From:
To: Selim <Selim@sawayaeng.com>
Cc: Ara Mihranian; Jill Martin <jmartin@trumpnational.com>; Rehm, Zach@Coastal <Zach.Rehm@coastal.ca.gov>
Subject: RE: Tract 50666 Fencing plan

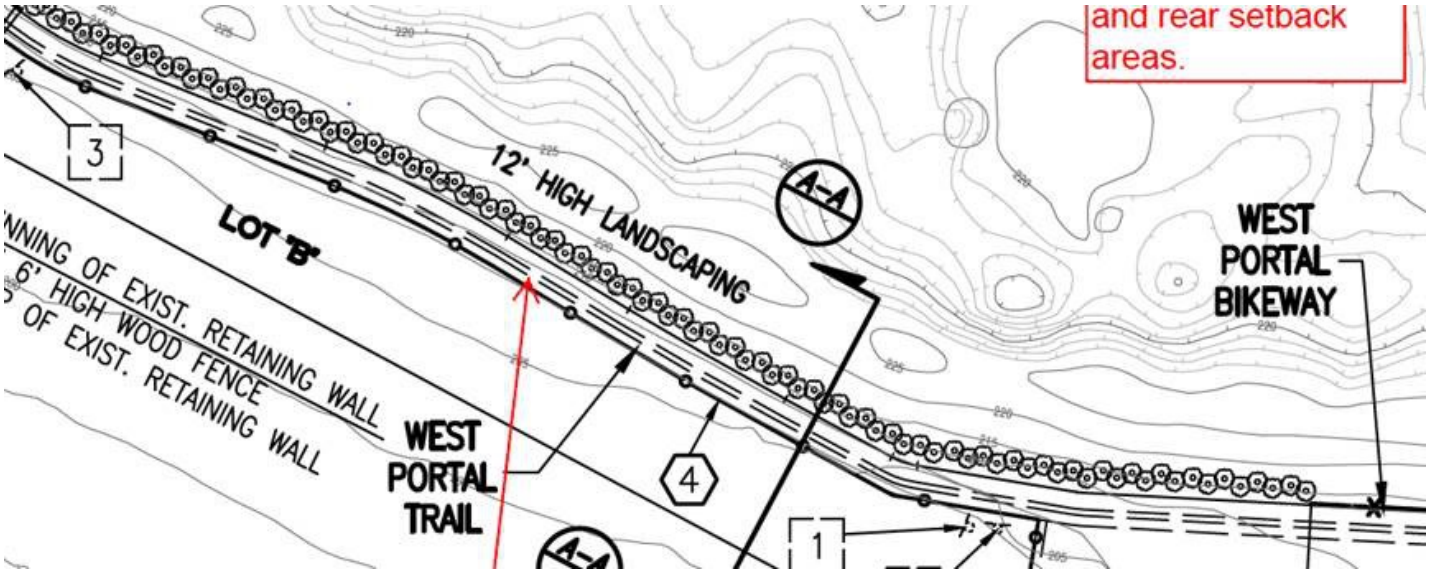
1) Change the notation "12' HIGH LANDSCAPING" to "LANDSCAPING NOT TO EXCEED 12' IN HEIGHT OR THE RIDGE ELEVATION OF THE SOUTHERLY BERM". Based on your map, it appears that the ridge elevation of southerly berm would be 225.

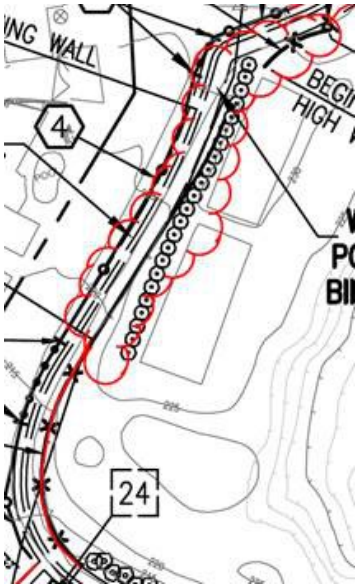
2) Based on Mitigation Measure H-1 above, remove the 6' tall fence located in the bubbled area since there is already a hedge there and begin the fence from the south end of the west hedge to the west end of the south hedge as shown in the solid red line below. Please change the notation from "6' HIGH LATTICE" to "LATTICE FENCE NOT TO EXCEED 6' IN HEIGHT OR THE RIDGE ELEVATION OR THE SOUTHERLY BERM".
